ULNRC-04993

**DOCKET NUMBER 50-483
CALLAWAY PLANT
UNION ELECTRIC CO.
REVISION OF REQUEST FOR RELIEF FROM ASME
SECTION XI REQUIREMENTS IN ORDER TO TEMPORARILY
RESTORE WALL THICKNESS OF ASME CLASS 2 CARBON STEEL
MAIN FEEDWATER PIPING BY WELD OVERLAY REINFORCEMENT**

Request to Restore Wall Thickness of ASME Class 2 Carbon Steel Main Feedwater Piping by Weld Overlay Reinforcement

Figure 1: Schematic of Overlay Configuration and Branch Reinforcement.

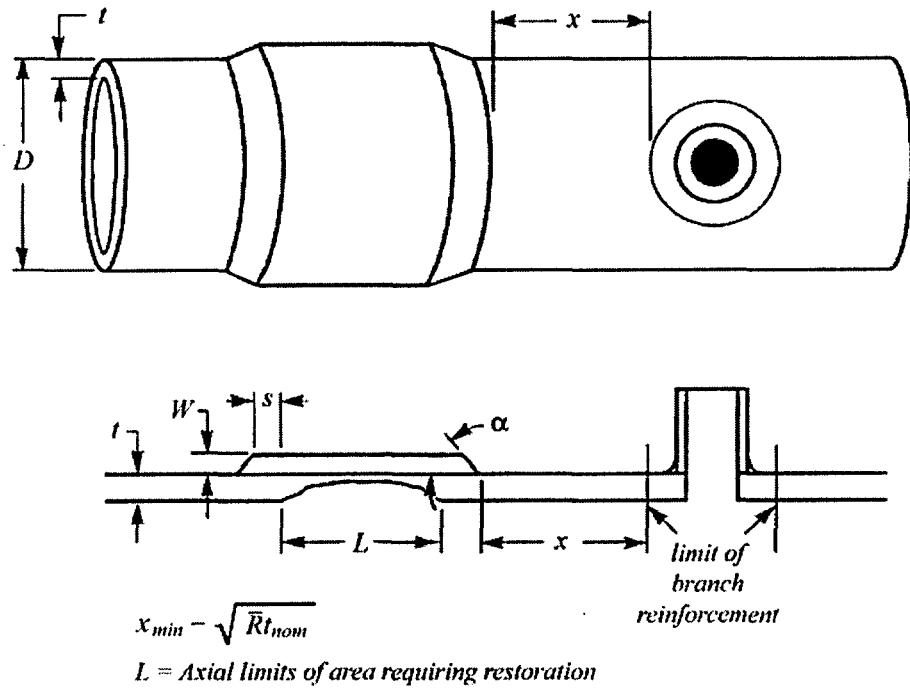
- 3.1. The thickness of the weld overlay reinforcement shall not exceed 1/4 inch. See thickness dimension W in Figure 1.
- 3.2. Evaluation of areas that require restoration by weld overlay shall consider the design life of the piping, future internal wall thinning in the weld overlay area, and shall be based on the design thickness as prescribed by ASME Section III².
- 3.3. The weld overlay shall have a uniform width and extend 360 degrees circumferentially around the piping.
- 3.4. Unless otherwise established by design analysis, the weld overlay shall extend axially a distance of at least s in each direction beyond the area that requires restoration, where s is defined as:

- 3.5. Edges of the weld overlay shall be tapered to the existing piping surface to a maximum angle of 45°. See angle α shown in Figure 1.
- 3.6. Final configuration of the weld overlay reinforcement shall permit nondestructive examination as required in 5.1 and 5.2.
- 3.7. Except for the tapered edges, the weld overlay reinforcement shall have a uniform thickness.
- 3.8. Tensile strength of the weld filler metal used for the overlay shall be at least that specified for the piping base material.

Figure 2: Drawing M-23AE04 Main Feedwater

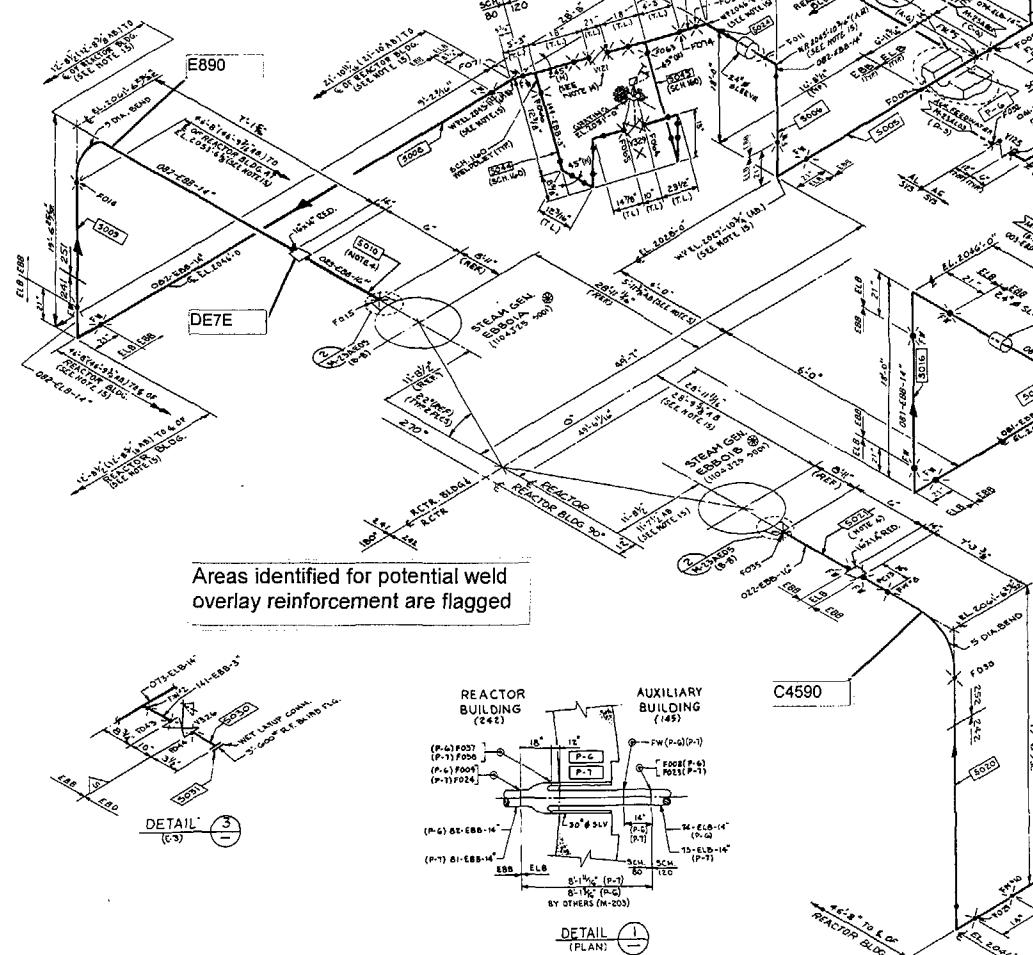
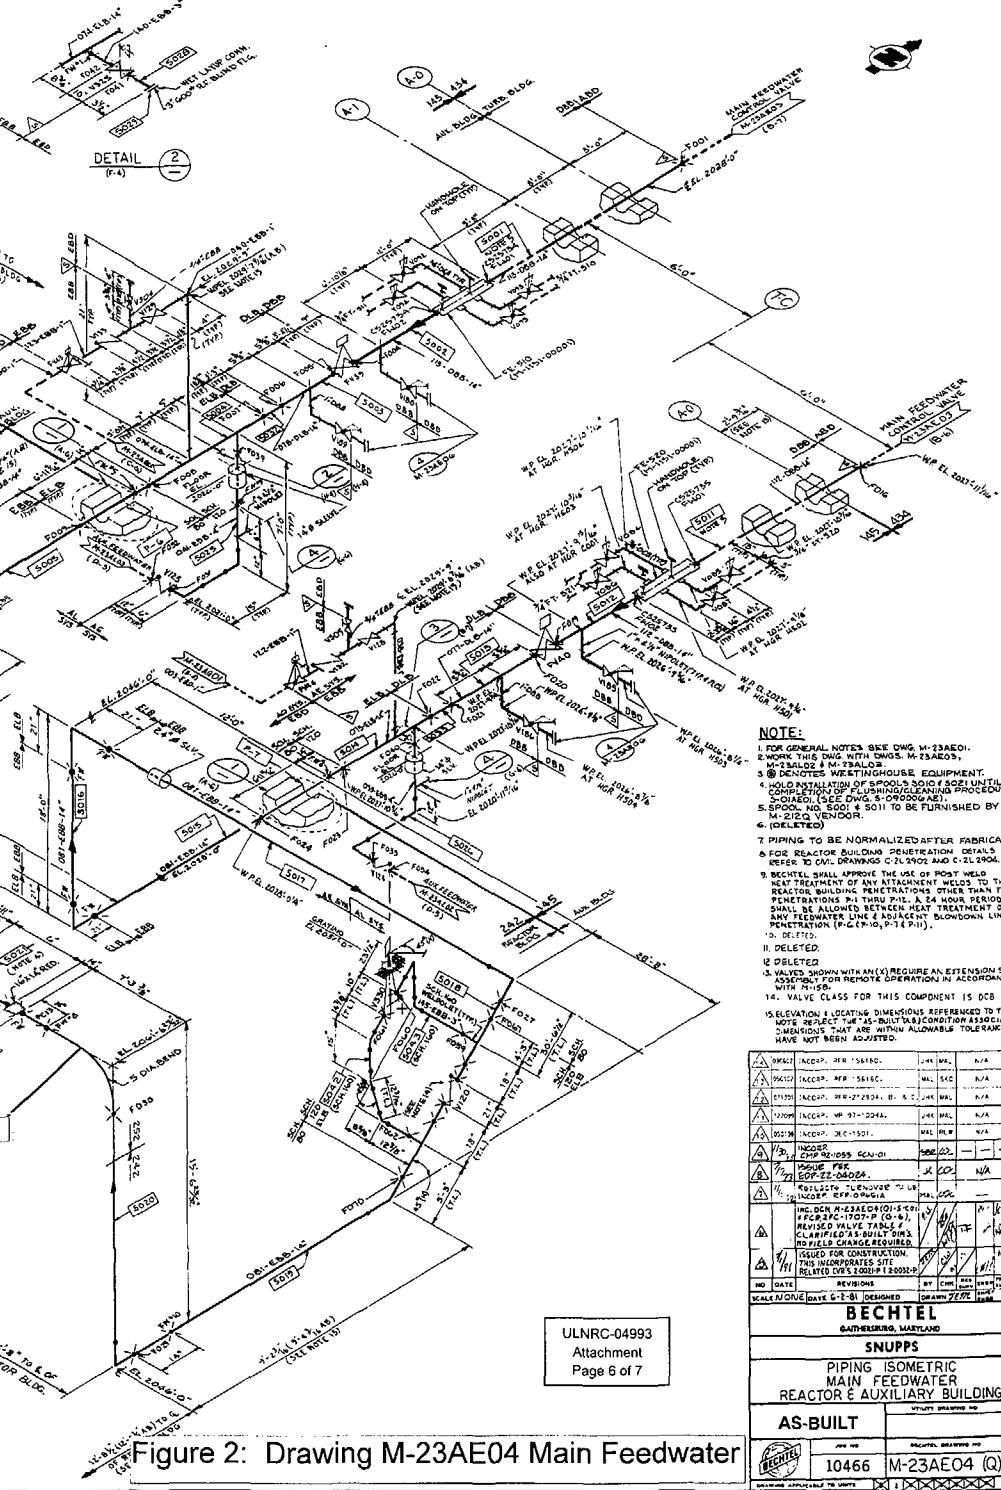
Areas identified for potential weld overlay reinforcement are flagged

Figure 3: Drawing M-23AE05 Main Feedwater

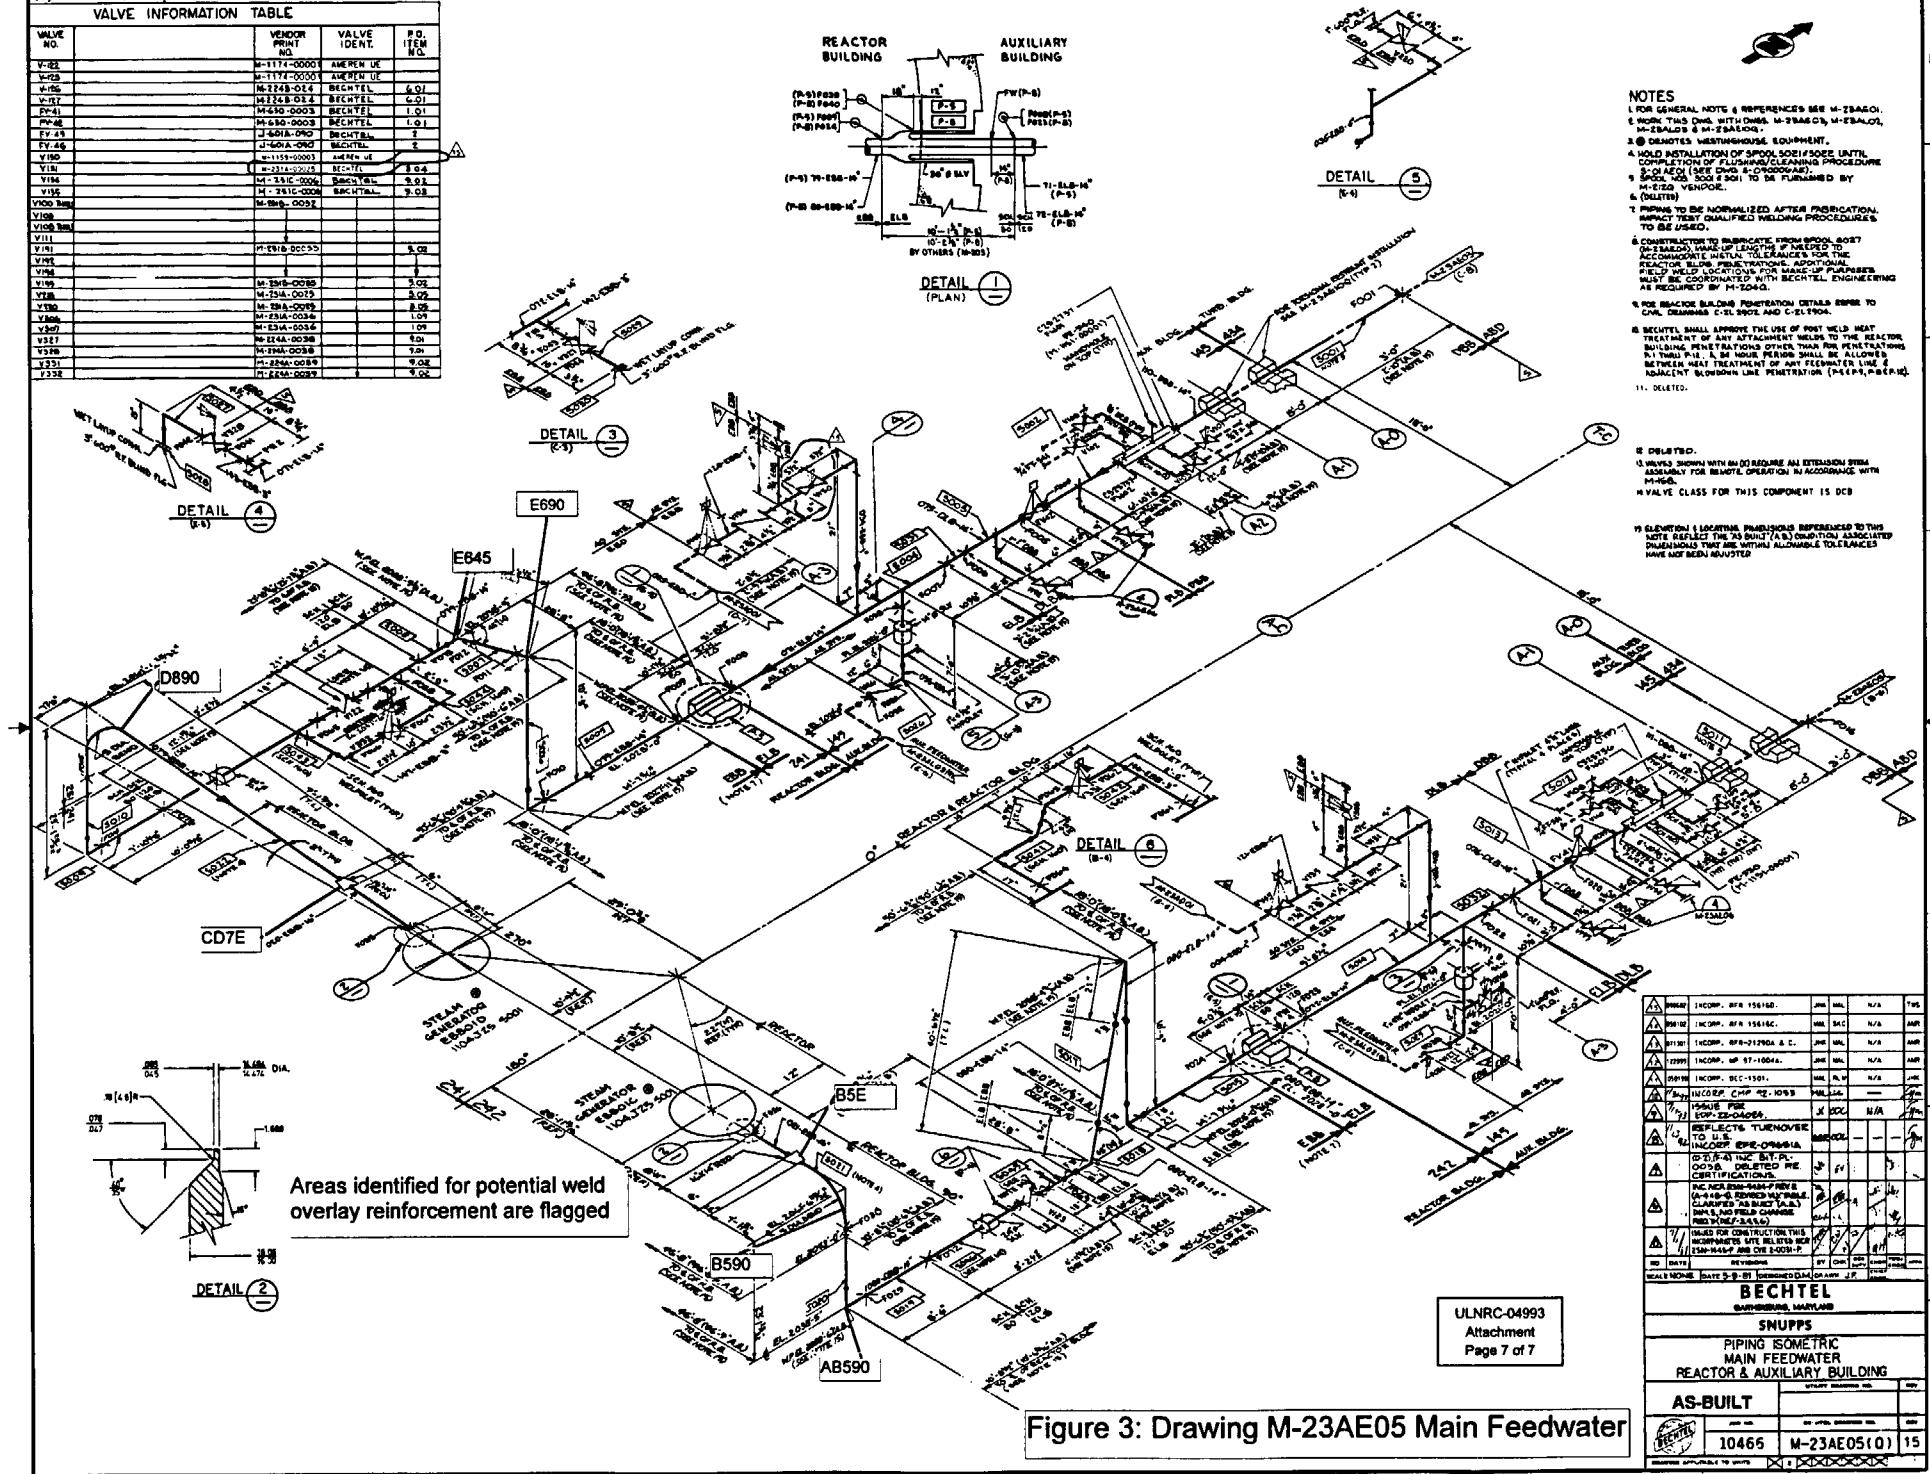
As noted previously, all of the pipe sections identified in AmerenUE's approved relief request are associated with the main feedwater system at Callaway. The pipe section identified for weld overlay is at a 90° elbow upstream from the 45° elbow identified as one of the pipe sections in the relief request. Pipe wall thinning was confirmed in an upstream area of the 90° elbow. This pipe section was not previously identified as one particularly susceptible to pipe wall thinning, and so it was not included in the list of affected pipe sections in AmerenUE's relief request. Nevertheless, the section was still subject to inspection under the FAC program, and results from that inspection have confirmed the need for overlay reinforcement based on the approach that was to be taken for the other identified pipe sections. It is important to note the justification for weld overlay reinforcement that was provided for the identified pipe sections in the approved relief request applies to this pipe section as well. That is, weld overlay reinforcement will restore the wall thickness of the piping to a value greater than design minimum wall thickness with adequate margin, taking into account the determined wear rate, for a service life of one operating cycle. Overlay reinforcement of this pipe section will thus ensure a sufficient level of safety and provide adequate structural integrity for one operating cycle.
